Re: *In the Matter of the Application for the Biers Run-Hopetown-Delano 138kV
Transmission Line Project*
OPSB Case No. 13-0429-EL-BTX

With the attached Second Supplement to the Application, AEP is submitting an alternative route across the Pleasant Valley Wildlife Area, which is now the Current Preferred Route. References to the original Preferred Route in the Application dated January 8, 2014 and the Supplement to the Application dated May 5, 2014 are now to be considered the "South Alternate Route." References to the original Alternate Route in the previous submittals are now to be considered the "North Alternate Route." These routes and the appropriate name changes are provided in Figure 1 of the attached Second Supplement to the Application.

**FIGURE 1
PROJECT OVERVIEW
SECOND SUPPLEMENT TO
THE OPSB APPLICATION**

**FIGURE 01-1
PROJECT OVERVIEW
REVISION 2**

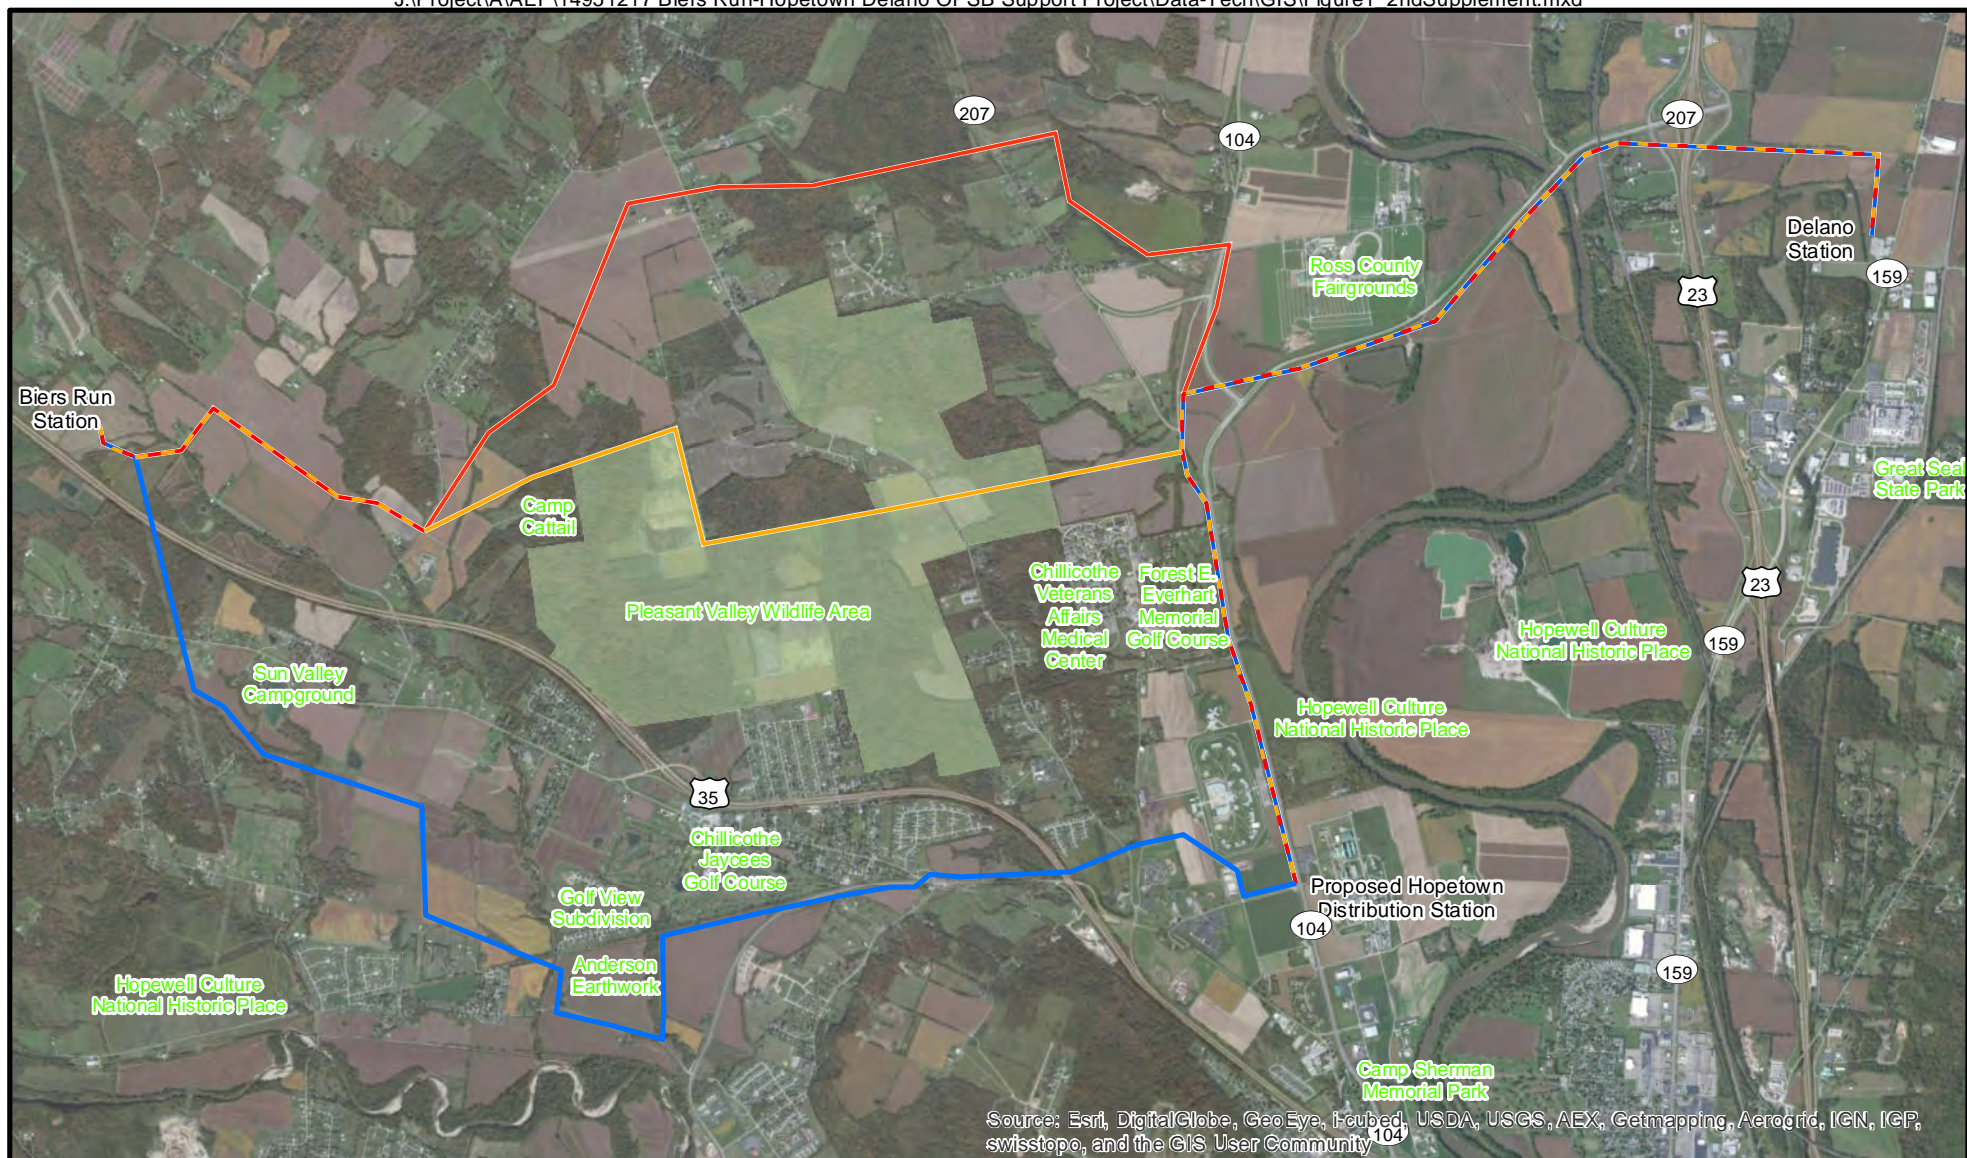
Based on public comments and support, results of the field surveys, and preliminary engineering evaluation, AEP is submitting the route across PVWA as the Current Preferred Route in this Second Supplement to the OPSB Application. References to the original Preferred Route in the Application dated January 8, 2014 and the Supplement to the Application dated May 5, 2014 are now to be considered the "South Alternate Route." References to the original Alternate Route in the previous submittals are now to be considered the "North Alternate Route." These routes and the appropriate name changes are provided in Figure 1 of this Second Supplement to the OPSB Application.

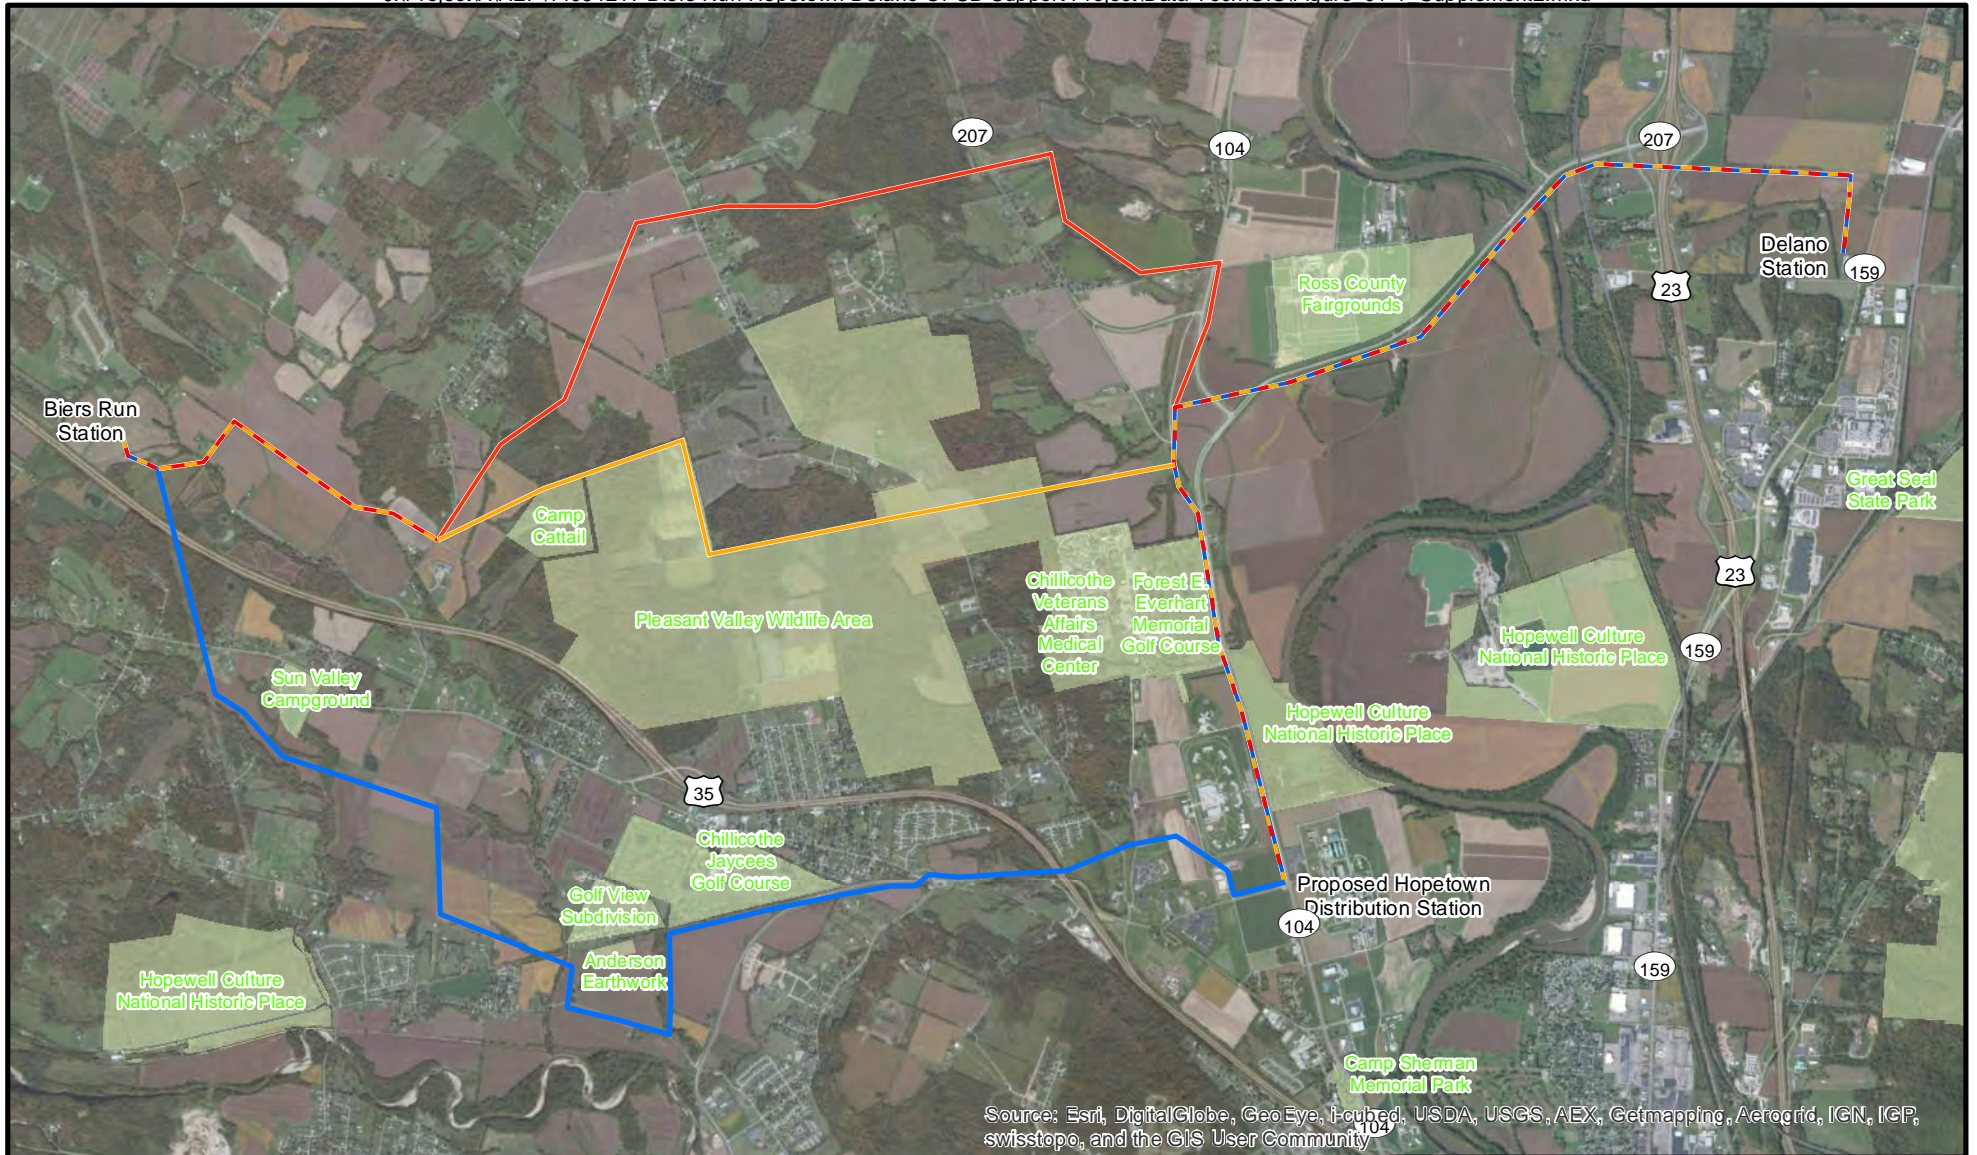
Current Preferred Route: The Current Preferred Route begins at the proposed Biers Run Station (OPSB Case Number 12-1361-EL-BSB), and crosses a short section of the overall station property. The first 0.2 mile of the Current Preferred Route as it exits Biers Run Station is shared by the North Alternate Route and South Alternate Route. The Current Preferred Route then heads generally east-southeast for 1.5 miles, sharing the same path as the North Alternate Route, primarily along property lines to Cattail Road. The route continues for 0.7 mile across a property owned by the Ross County Commissioners and occupied by a juvenile detention center and Camp Cattail before entering the ODNr's PVWA. The Current Preferred Route generally parallels the northern boundary of the irregularly shaped PVWA for approximately 2.0 miles to Egypt Pike. After crossing Egypt Pike, the route continues within the boundary of PVWA and then across a privately owned agricultural property for 1.0 mile to a point near the intersection of State Route 104 and State Route 207 where it meets the current right-of-way of the Camp Sherman-Circleville 69 kV line (Common Route). To this point, the Current Preferred Route will be constructed as a single circuit. However, the 2.0-mile portion of the Common Route heading

south parallel to State Route 104 and within the current right-of-way of the Camp Sherman-Circleville 69 kV line to the proposed Hopetown distribution station will require double circuit construction if the Current Preferred Route is selected. This is necessary to create a loop through the proposed Hopetown distribution station and back to the point where the Current Preferred Route and the Common Route intersect. The Camp Sherman-Circleville 69 kV line will be removed prior to construction of this portion of the Biers Run-Hopetown-Delano 138 kV transmission line. A single circuit will extend east along the Common Route heading north, then generally east and northeast parallel to State Route 207 for 2.6 miles. The route then crosses a U.S. 23 interchange, extending east and then south across agricultural fields for the final 1.2 miles into Delano Station. The total length of the Current Preferred Route is 11.2 miles.

SUPPLEMENTAL FIGURE 04-2G
SINGLE CIRCUIT, DELTA, ZERO DEGREE
BRACED POST WITH CORONA RING,
STEEL STRUCTURE

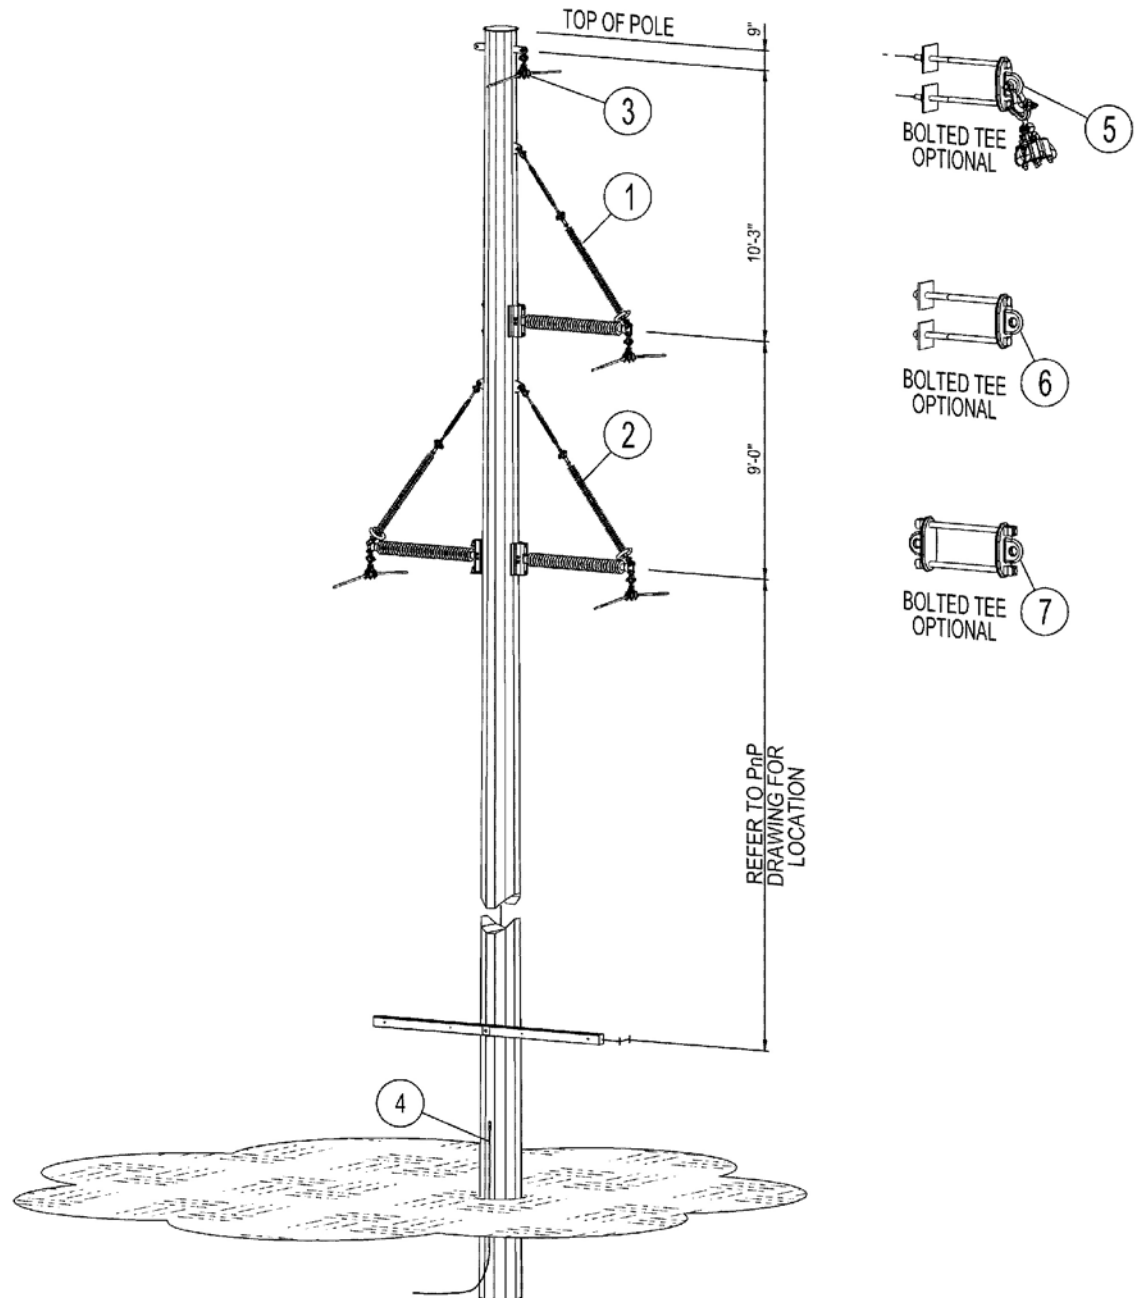
Based on the alignment of the Current Preferred Route and the resulting current design, the majority of the line will be composed of a steel tangent, braced post, delta structure (see Supplemental Figure 04-2G).
